Campaign no. 99001

No. **99-1**

Date: November 26, 1998

SUBJECT: Pick-Up Wire

1. Pick-up bracket
2. Wire bracket in contact with top of pick-up bracket

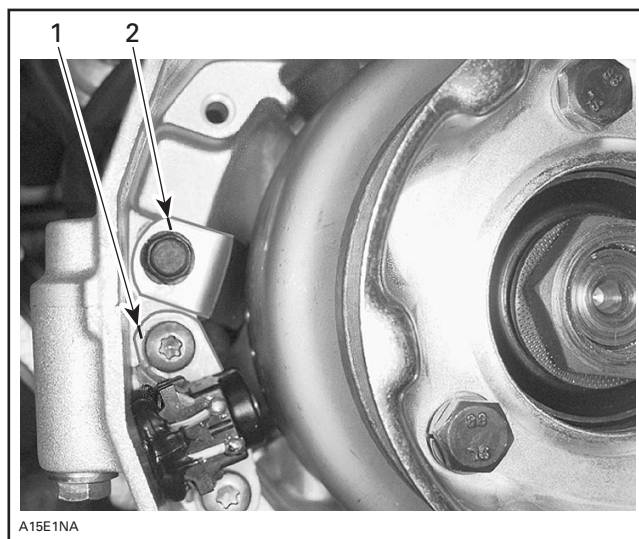
2. If distance is not sufficient or
3. If pick-up wire visual inspection reveals that **outer protective sleeve** starts to be worn, proceed with bracket installation and identify unit as "done" with an X in rectangle on top of magneto housing, using a marker.

Using already existing hole in casting secure pick-up wire with bracket and self-tapping screw, apply Loctite 242 (blue) (P/N 293 800 015) on screw and torque to 10-12 N•m (7-9 lbf•ft). Note that bracket must be installed with its lower edge in contact with top of pick-up bracket. Refer to following photo.

Reinstall all removed parts.

Identify unit as "done" with an X in rectangle on top of magneto housing, using a marker.

- 1. Welded arm
- 2. Shock absorber support
- 3. Upper tube
- 4. Lower tube
- 5. Tube protector
- 6. Axle

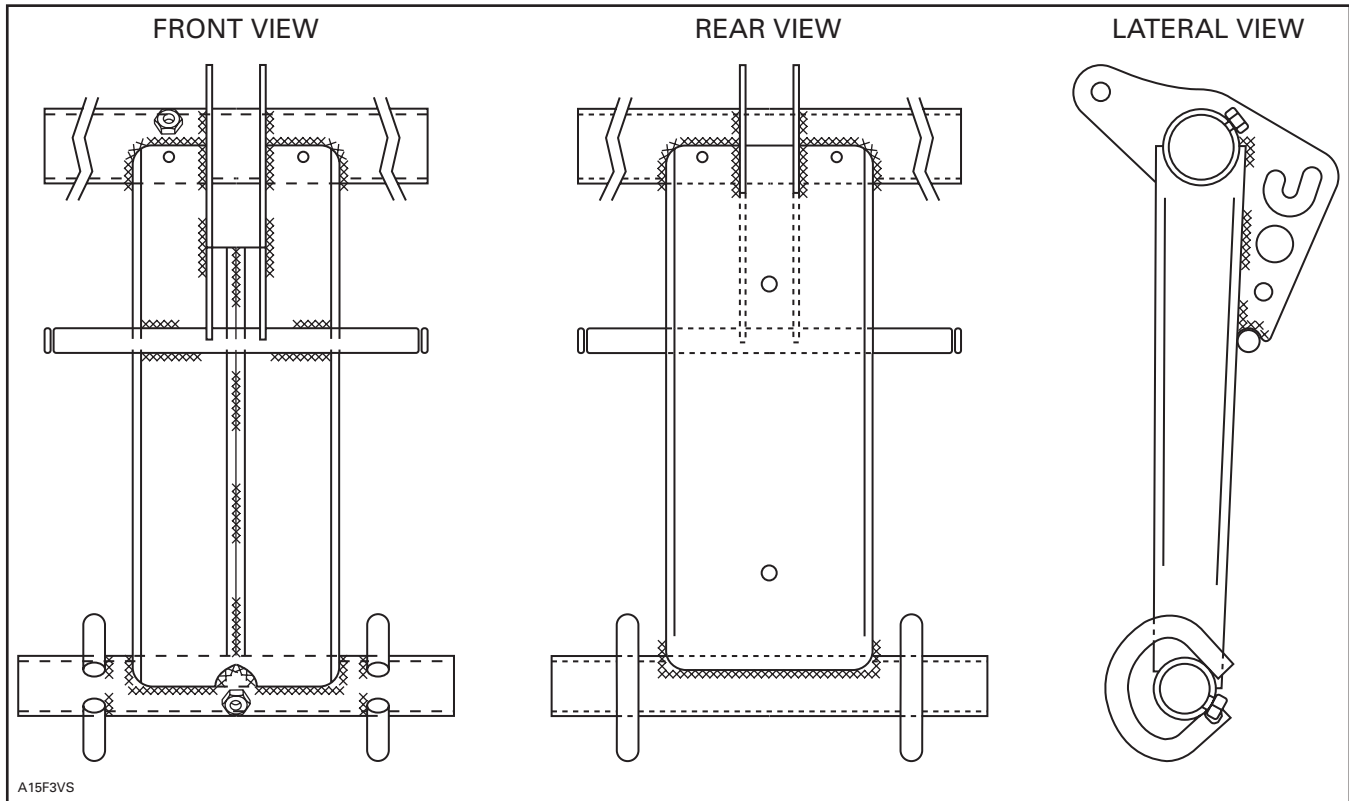
Perform a complete inspection as per following FRONT VIEW, REAR VIEW and LATERAL VIEW illustrations.

WELDING SEAMS ARE SHOWN WITH XXXX

Pay closer attention to following welded seams:

- arm to lower tube, at front and at rear
- axle to arm
- arm to upper tube, at front

Should a single omission be detected, rear arm must be replaced.

Do not attempt to perform welding since strict specifications must be adhered to.

1. Throttle slide
2. 1.3 mm (0.051 in) bit inserted for proper gap
3. Manual adjustment before tightening screw

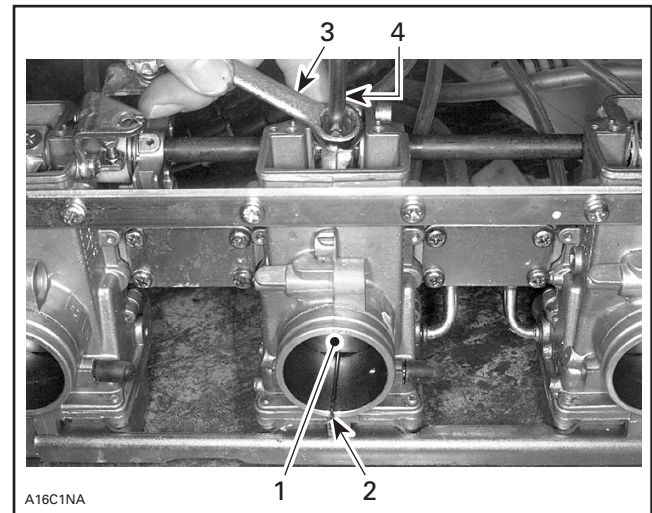
- section 04-08 for proper carburetor components replacement,
- jet needle clips adjusted to position 4,
- cut-away height to 1.3 mm (0.051 in),

START WITH PTO SIDE CARBURETOR

CAUTION: Make sure all three cut-aways are adjusted according to specification without difference in height. **Failure to do so will cause severe engine damage.**

IMPORTANT: When proper height is attained, tighten screw. Reverify cut-away height and readjust if necessary till specified height is reached on all three carburetors.

1. Brake hose
2. Potentially faulty harness

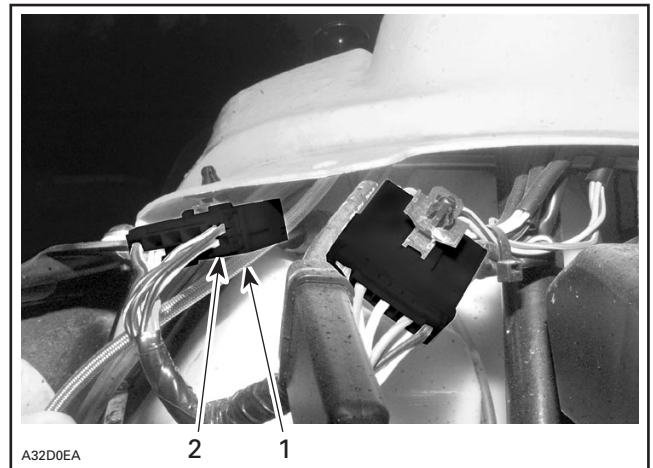
- A. Inspect brake hose and electrical harness and relocate brake hose if no sign of wear is found.
- B. Inspect brake hose and if sign of wear is found, replace brake hose, relocate and secure it. Fix harness if needed.

Check for wear of both parts.

1. Fitting to be plugged up on pressure manifold
2. Vent hose **not to be plugged up nor removed**

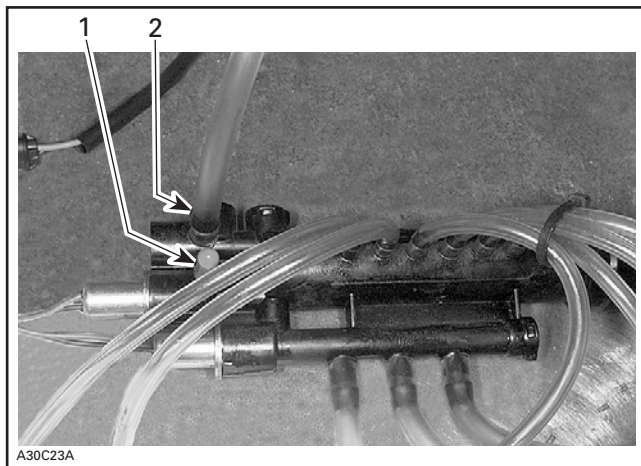
Using third and last cap **no. 9**, plug up air pump inlet fitting on air pressure manifold.

CAUTION: Ensure proper fitting is plugged up otherwise, severe engine damage will occur.

1. This outlet fitting **must be plugged up**

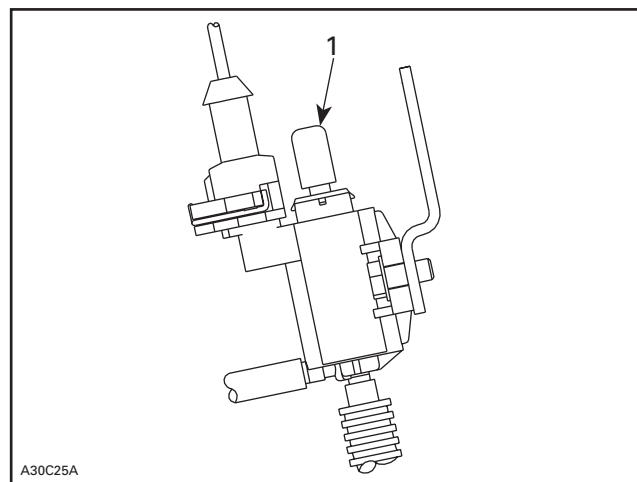
Using cap no. 3, plug up top outlet fitting on solenoid valve. Refer to following illustration.

Top outlet fitting on solenoid valve **must be plugged up** or fuel may exit and cause damage. Fuel is flammable and explosive under certain conditions. Always wipe off any fuel or oil spillage from the vehicle. Ensure work area is well ventilated. Do not smoke or allow open flames or sparks in the vicinity.

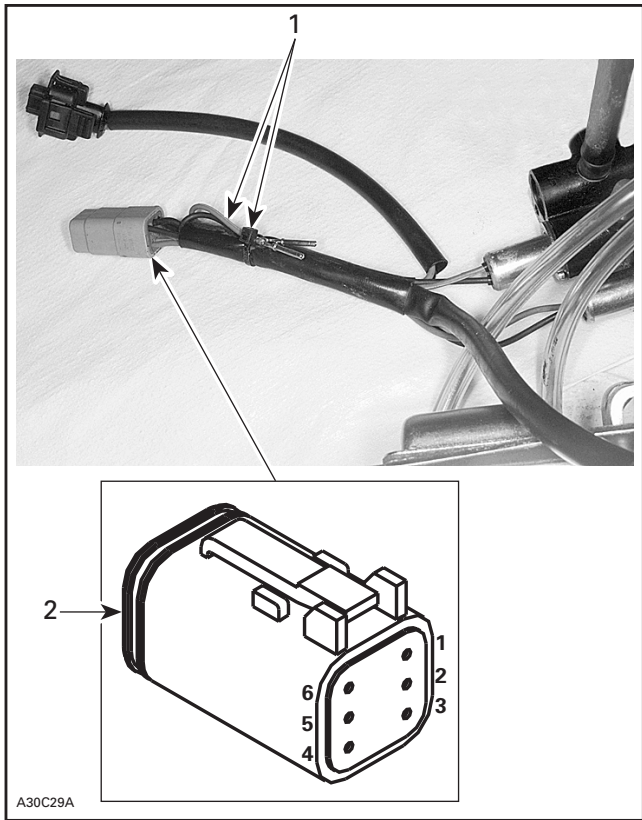
From DPM electrical harness male connector housing, remove RED-GREEN wire (position 2 in illustration below) and its BLACK wire (position 5 in illustration below), fold them backward onto their plastic protector and secure them in place with a locking tie no. 10. This will cancel this enrichment solenoid.

Ensure you remove the good wires from connector (the ones from enrichment solenoid), refer to following illustration.
